# SERVICE BULLETIN

M-1041

Safety Recall Code 085

## FLTCU/FLHTCU THROTTLE/IDLE CONTROL CABLES

Figure 4. Cut Shrink Tubing from Female Spades

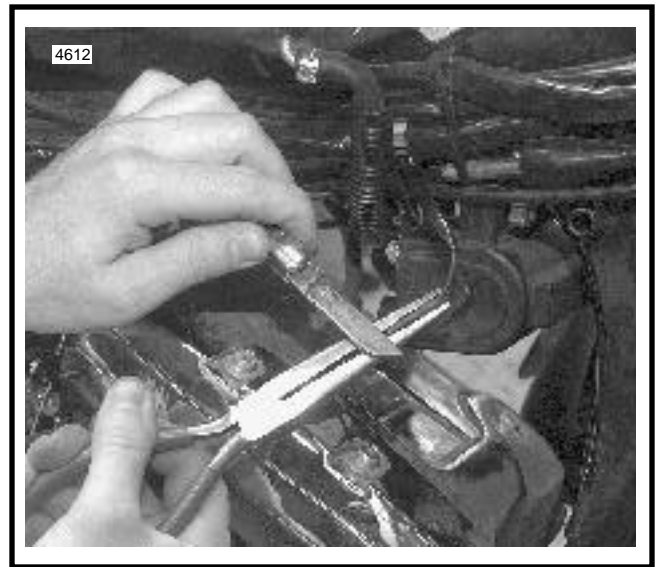
5. With a needle nose pliers, grasp the female spade type wire terminal the long way (see Figure 4). Using a sharp knife, make a cut the full length of the shrink tubing. Exercise caution to avoid cutting the wire beneath the shrink tubing material. Peel off the shrink tubing material and discard. Repeat the procedure to remove the tubing material from the other terminal.

Figure 3. Throttle/Idle Control Cable Configuration (Right Side View) - 1993 Models

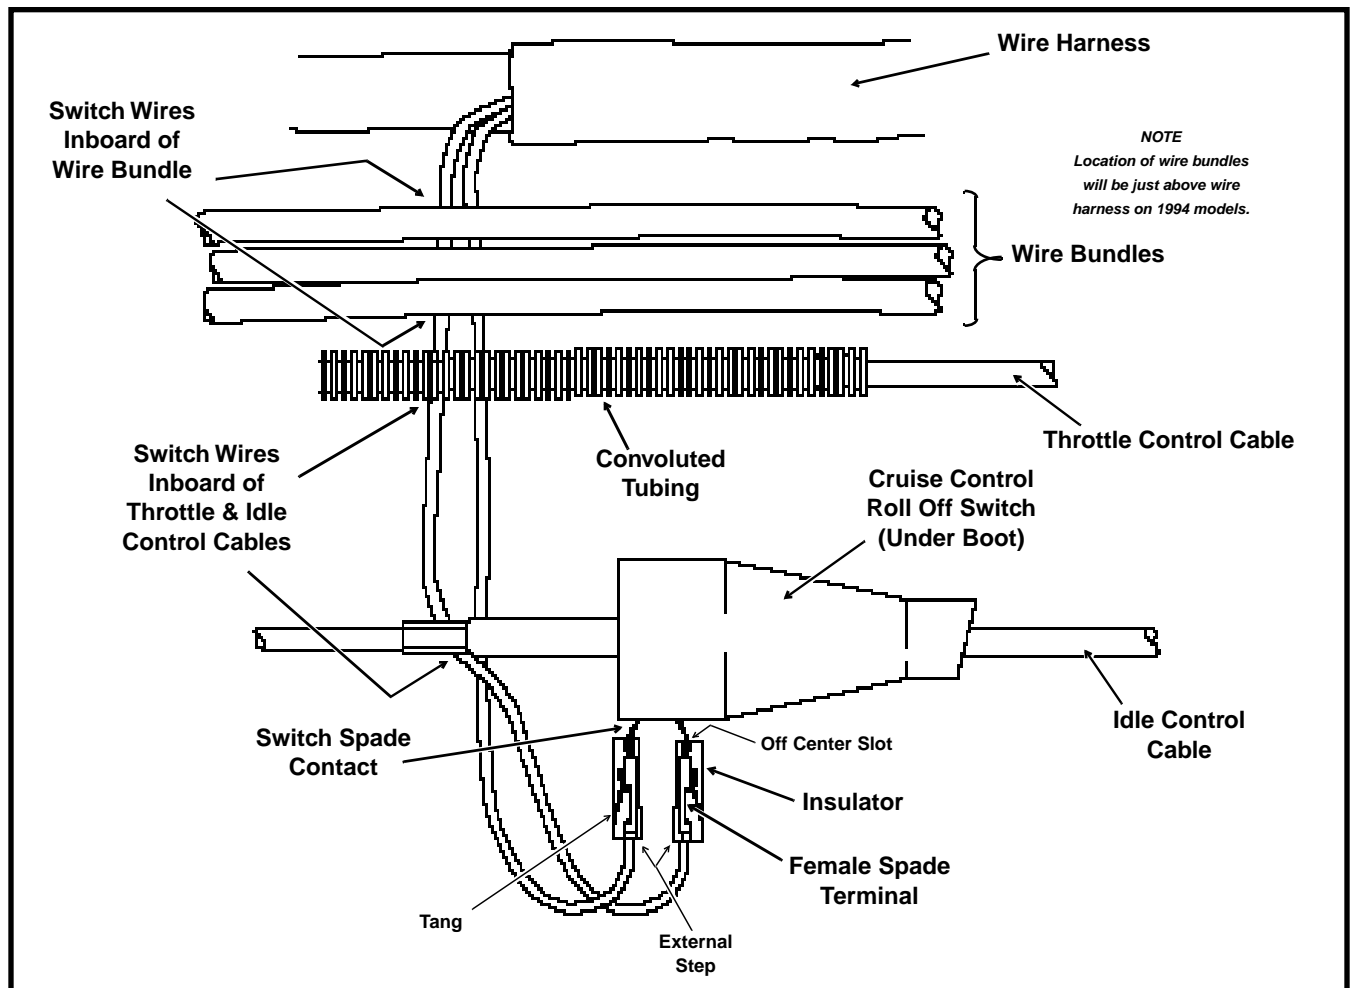
1. Locate the cruise control roll off switch plumbed into the idle control cable on the right side of the vehicle (see Figure 3). Push rubber boot on switch forward to access spade type wire terminals.

2. Carefully examine both the idle and throttle control cables in the vicinity of the switch. If any melting of the black vinyl coating is observed, replace the affected cable following the appropriate procedures outlined in the 1993 and 1994 FLT/FXR Service Manual (see Credit Procedures for reimbursement details). After replacing the cable(s), proceed with step 3.

8. Slide the insulators onto the switch spade contacts (polarity is not a factor). For maximum insertion, be sure that the external step on the insulators face each other (see Figure 3).

Figure 5. Install Insulators on Female Spade Terminals

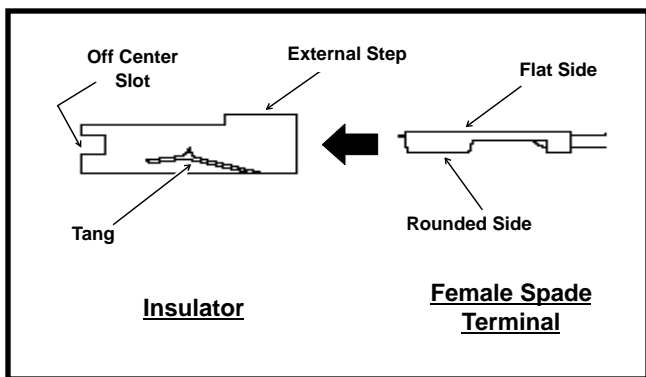
If the insulators are installed backwards (where the tang engages the flat side of the female spade terminal), the insulator will only be partially installed and removal may not be possible without damage to the wire and/or crimped connections.

6. Insert the female spade type terminal into the insulator. Be sure the flat side of the spade faces the external step on the insulator (see Figure 5). The insulator will snap or click into place when fully installed.

Figure 6. Leave Switch Wires Out of Cable Strap (Right Side View) - 1993 Models

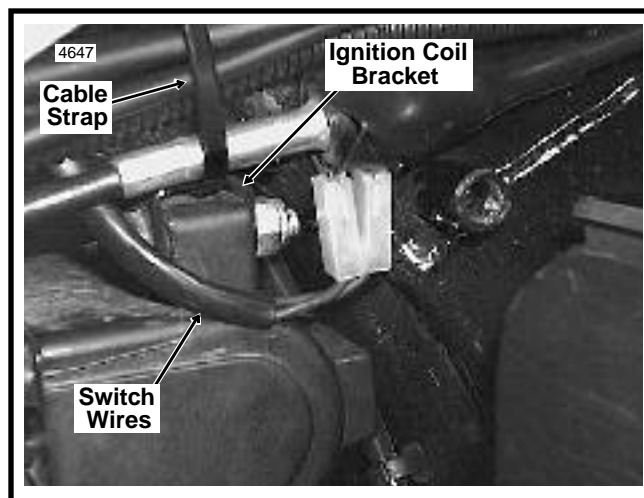
Switch wires may become kinked if captured in cable strap, or contact with threaded end of coil bracket bolt may fray switch wire insulation, resulting in a short to ground. Shorted switch wires will cancel operation of cruise control and brake light functions, the latter condition posing a significant hazard to the rider.

14. On 1993 models, verify that the cruise control roll off switch wires are **not** captured within the cable strap. The switch wires must be routed outboard and to the rear of the ignition coil bracket (see Figure 6). The ignition module wires (left side of vehicle above ignition coil) must also be left outside the cable strap (see Figure 7).

**Figure 8. Install Cable Strap**

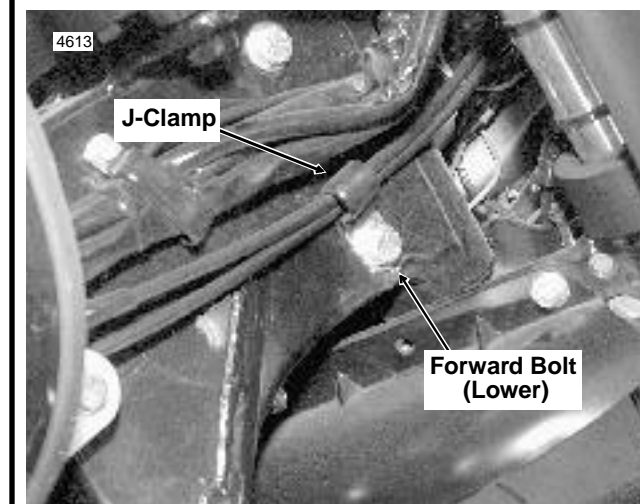
- Cut and discard old 14 inch cable strap around frame backbone, wire harness and wire bundle, if present. (See cable strap callout in Figures 2 and 8.)

15. On right side of vehicle, verify that the idle and throttle control cables, wire bundles, wire harness and frame backbone are captured before mating strap ends (see Figure 8). Tighten cable strap, but leave loose enough so that one finger can be inserted between strap and frame backbone. **Do not overtighten.** Cut any excess cable strap material.

**Figure 10. Remove Plug From Frame (Right Side View)**

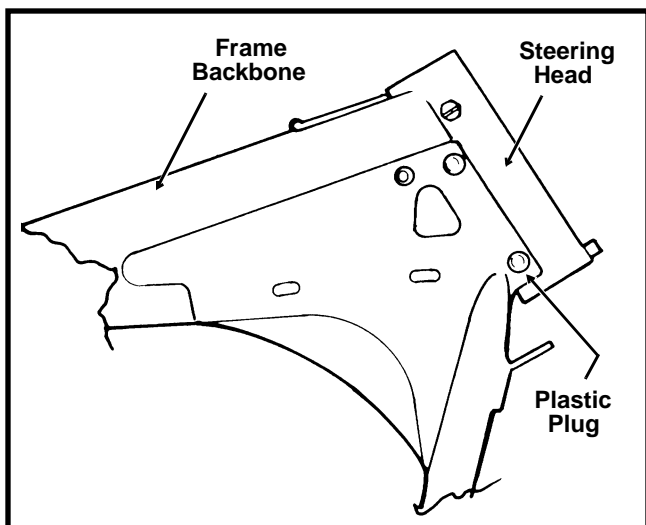
**FLHTCU:** Using the sharp edge of a knife, carefully pull out the plastic plug in forward area of frame (see Figure 10). Install wellnut from recall kit in hole. Install flat washer and J-clamp on screw. Start screw into wellnut. With the loop of the clamp orientated at the top, tighten the clamp screw until snug.
